SUBJECT: POINT BEACH NUCLEAR PLANT, UNITS 1 AND 2 - STAFF ASSESSMENT OF INFORMATION PROVIDED PURSUANT TO TITLE 10 OF THE *CODE OF FEDERAL REGULATIONS* PART 50, SECTION 50.54(f), SEISMIC HAZARD REEVALUATIONS FOR RECOMMENDATION 2.1 OF THE NEAR-TERM TASK FORCE REVIEW OF INSIGHTS FROM THE FUKUSHIMA DAI-ICHI ACCIDENT (TAC NOS. MF3959 AND MF3960)

STAFF ASSESSMENT BY THE OFFICE OF NUCLEAR REACTOR REGULATION
RELATED TO SEISMIC HAZARD AND SCREENING REPORT
POINT BEACH NUCLEAR PLANT, UNITS 1 AND 2
DOCKET NOS. 50-266 and 50-301

Figure 3.3-1 Plot of Staff's and Licensee's Base Case Shear-Wave Velocity Profiles for the Point Beach Site

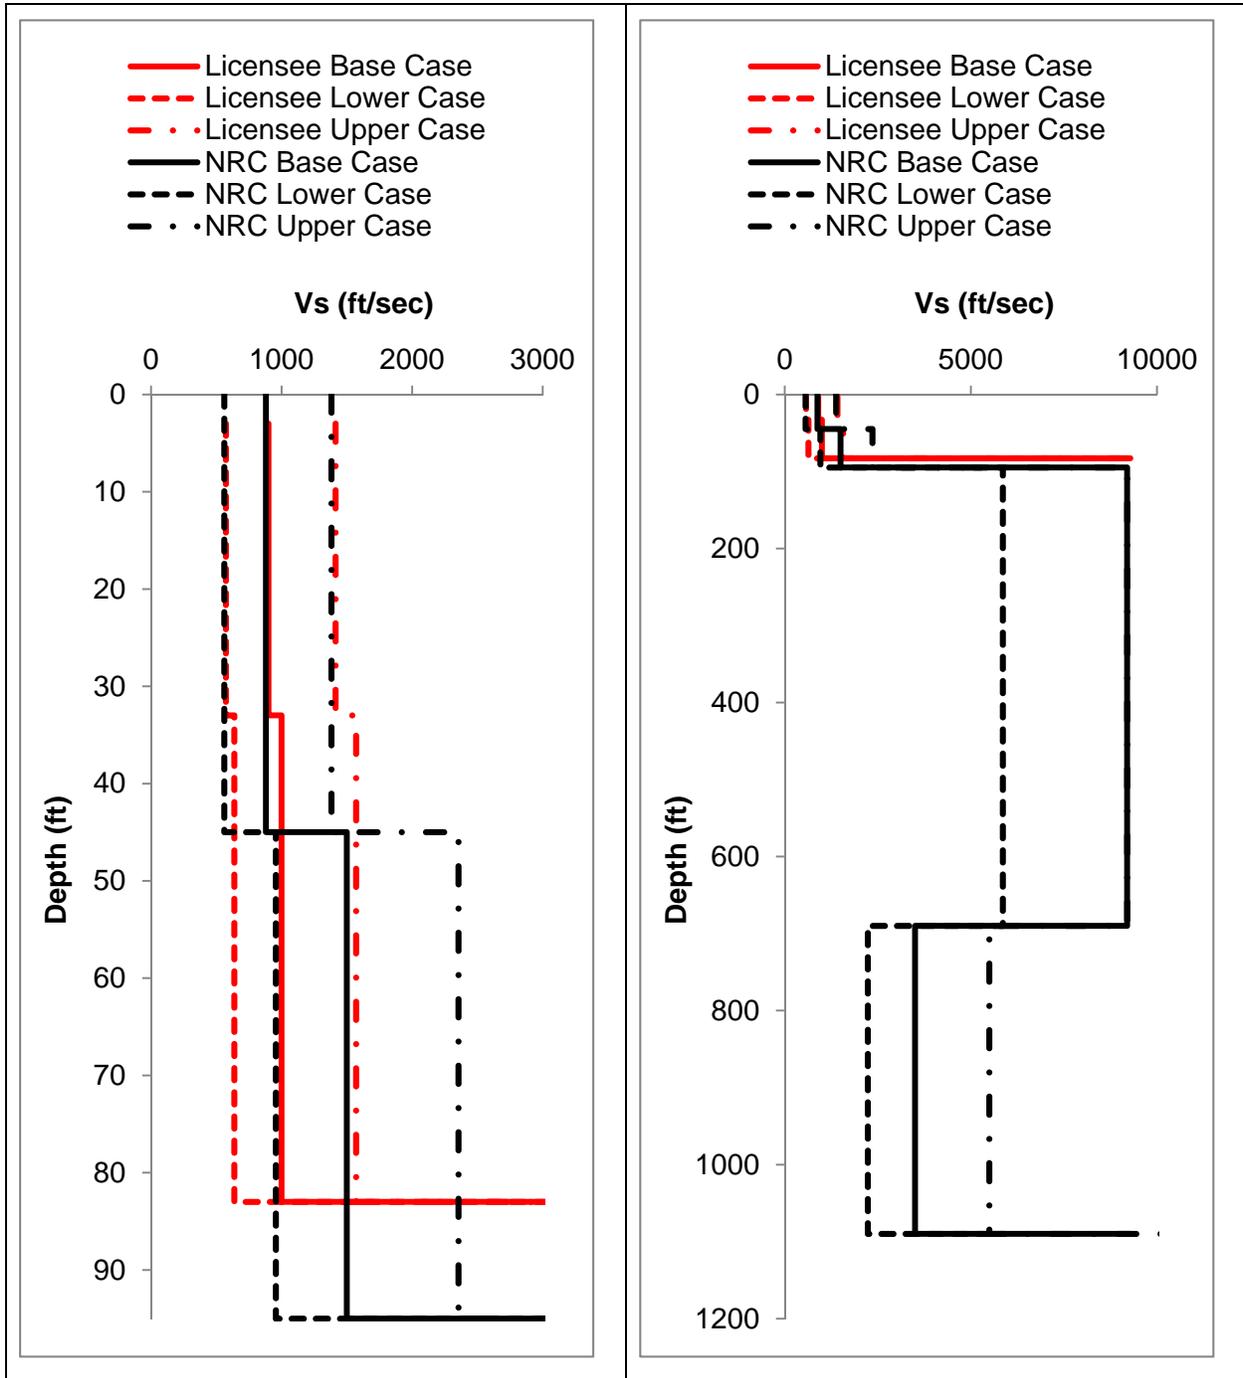
Using these measured shear-wave velocity estimates, along with guidance provided in the SPID, the licensee developed the best-estimate shear-wave velocity profile. The licensee also developed upper and lower base case profiles using a scale factor of 1.57, which implies a natural log standard deviation of 0.35, following guidance in the SPID. This approach to developing base case profiles resulted in three profiles, which are shown below in Figure 3.3-1 of this assessment.

Using the guidance provided in the SPID for the determination of site kappa resulted in values of 0.010 sec, 0.015 sec and 0.007 sec for the base, lower and upper base case profiles, respectively. These values are slightly higher than the licensee's values due to the additional depth to base rock in the NRC staff's profiles. In addition, to account for the aleatory variability in material properties across the plant site, the NRC staff randomized its base case shear-wave velocity profiles following the SPID guidance provided in Appendix B of the SPID.

Figure 3.3- 1 Plot Comparing the NRC staff's and the Licensee's Median Amplification Functions and Uncertainties for the Point Beach site.

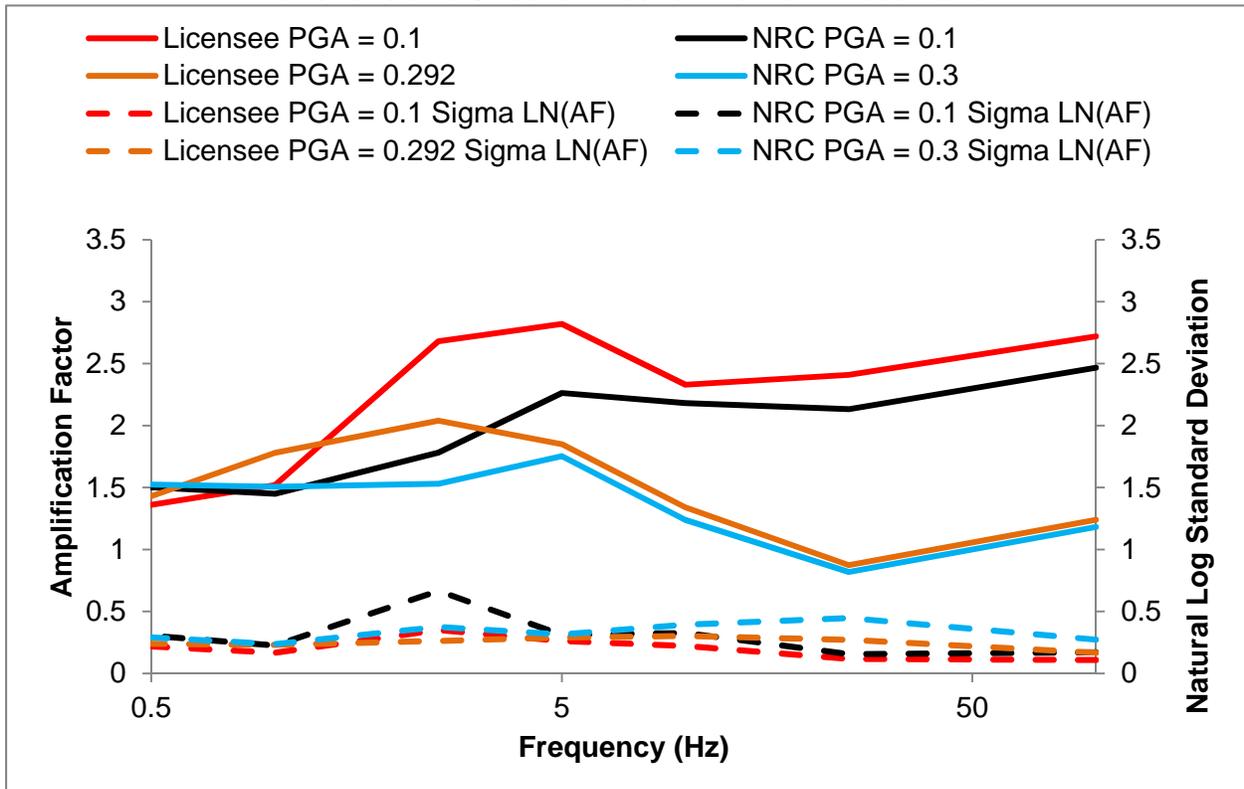
In order to calculate control point hazard curves for the Point Beach site, the licensee and NRC staff developed median amplification functions for the site for several different loading levels. The median site amplification and associated uncertainty for two separate loading levels are shown in Figure 3.3-2 of this assessment. It can be seen that both the NRC staff's and licensee's site amplifications are similar in shape with small differences at peak amplification, which is due to the more shallow subsurface profile used by the licensee. The licensee's and staff's control point hazard curves resulting from the convolution of the site amplification with the PSHA rock hazard are shown in Figure 3.3-3 of this assessment. As shown in Figure 3.3-3, the licensee's and staff's control point hazard curves for the Point Beach site are very similar.
